STAFF REPORT: 8/10/2022 REGULAR MEETING

APPLICATION NUMBER: 22-8019

ADDRESS: 4770 LESLIE

SCOPE: REPLACE DOORS/WINDOWS, OTHER EXTERIOR ALTERATIONS (WORK STARTED WITHOUT APPROVAL)

Left to right: Proposed security door (image from application), proposed aluminum door (image from application), door already installed (photo from October 2022 site visit).

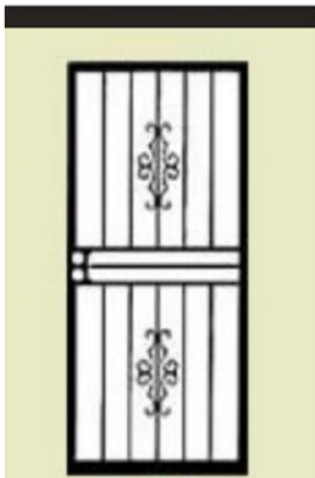
The applicant proposes a new aluminum side (east elevation) door; it appears that this door has already been installed. Also proposed is a black security door at the same location.

- Without information on the appearance of the historic side door, staff is unable to determine if it was a distinctive or defining feature, or when it was removed. However, the proposed door (already installed) is appropriate in that it is “clearly differentiated” (Standard #9) and does not introduce incompatible architectural elements.
- The above observations pertaining to the proposed front security door also apply to the proposed side security door.

- The bright white color of the side door is not appropriate for the period and style of the building. The door should be painted an appropriate color from Color System D.

- The design of the security doors shall be subject to approval by staff
- The side door shall be painted an appropriate color selection from Color System D
- The proposed replacement windows shall be subject to approval by staff
- Fascias and soffits may be replaced on the building's rear ell only; elsewhere, the existing fascias and soffits shall be preserved; and
- The design of the front porch and balcony railings shall be subject to approval by staff.
